APPENDIX "A"

The Approvals Authority's conditions and amendments to final approval for registration of this plan of condominium, File No. 39CD-09509 are as follows:

No.	Conditions
1)	This approval applies to the revised draft plan submitted by 1767127 Ontario Limited, prepared by Archibald Gray & McKay Engineering Ltd., certified by Bruce S. Baker OLS, File No. 39CD-09509, drawing no. L08080D4C3D.dwg, dated September 22, 2011, which shows a 21 unit draft plan of vacant condominium development located at 567 Rosecliffe Terrace.

PROPOSED RED LINE MODIFICATIONS

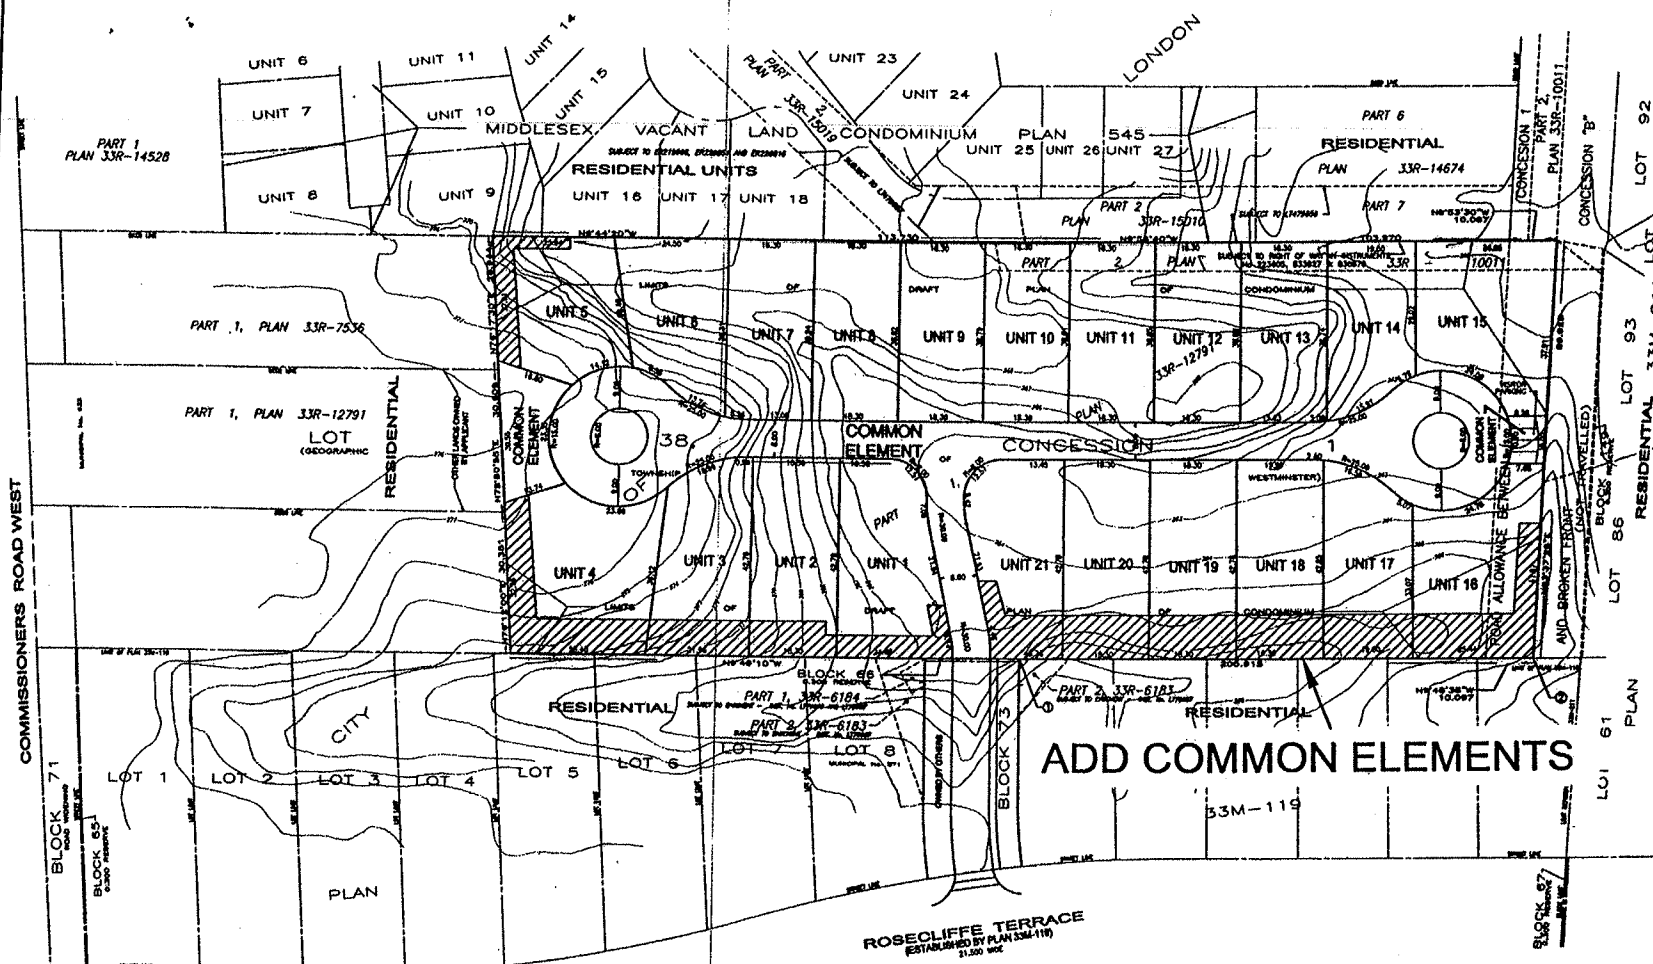
4)	The plan shall be amended in red to establish a common element block which includes retaining walls and landscape areas, as shown on the attached draft plan.

ADD COMMON ELEMENTS
